Delaware River Basin Commission

February 20, 2024

SUBJECT: DOCKET ID No. EPA-HQ-OW-2023-0222
“WATER QUALITY STANDARDS TO PROTECT AQUATIC LIFE IN THE DELAWARE RIVER”

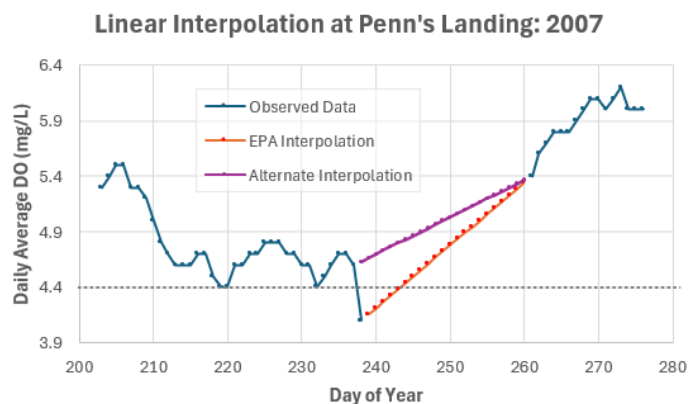
4. **Including flow in the GAM is unnecessary.** While it was worthwhile to consider, in practice removing flow as an independent variable does not meaningfully affect the predictive ability of the model (Chester w/ flow $R^2 = 0.774$ vs. w/o flow $R^2 = 0.760$ and Penn's Landing w/ flow $R^2 = 0.889$ vs. w/o flow $R^2 = 0.888$). It is preferable to select a simpler model (without flow) that performs just as well.

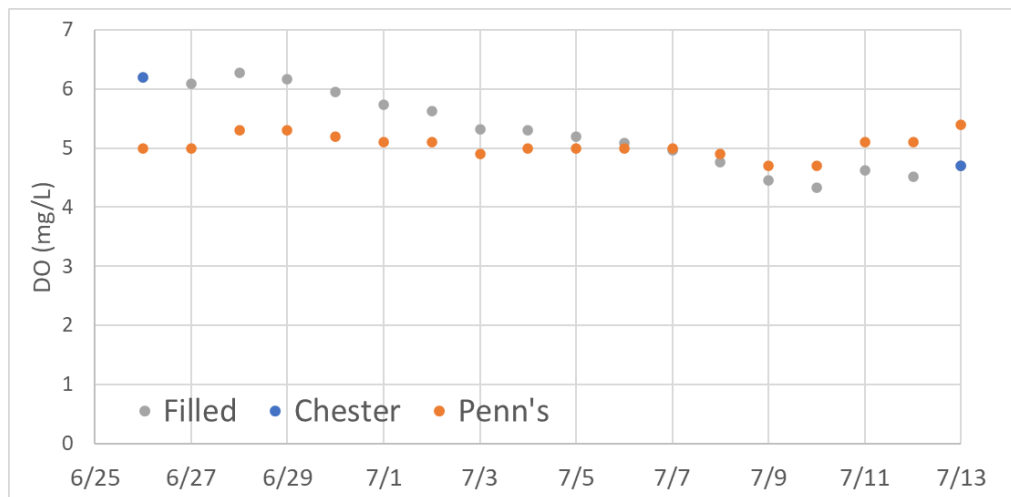
- **Specific suggestions to improve interpolation methodology**
 - Use all available observed data and avoid unnecessary interpolation by treating DO, conductivity, and temperature datasets independently. In the scripts EPA wrote, when processing observed DO, conductivity, and temperature data from Chester and Penn's Landing

gages, days that do not have values for all 3 parameters are removed from the dataset (using complete cases in R). Then, all 3 variables are linearly interpolated across those gaps. However, some days that are removed from the dataset may have had some data for other variables. For example, in 2020 at Penn’s Landing, 21 days with missing conductivity data are removed from all 3 observed data sets, though these 21 days do have DO and temperature data. In EPA’s methodology as reflected in its scripts, DO and temperature are interpolated across these 21 days instead of using the observations on those days.

- Consider a more sophisticated interpolation approach. While linear interpolation works well for very short gaps (1–2 days), another method would make sense for longer gaps, and some gaps are too long to reasonably fill via interpolation. EPA’s current methodology, linear interpolation was used for a 22-day data gap at Penn’s Landing in 2007. With 18% of the values for the 2007 Juvenile Development season being linearly interpolated, it would be prudent to remove this year from analysis. Thus, instead of simply filling all data gaps with linear interpolation, we suggest the following approach:
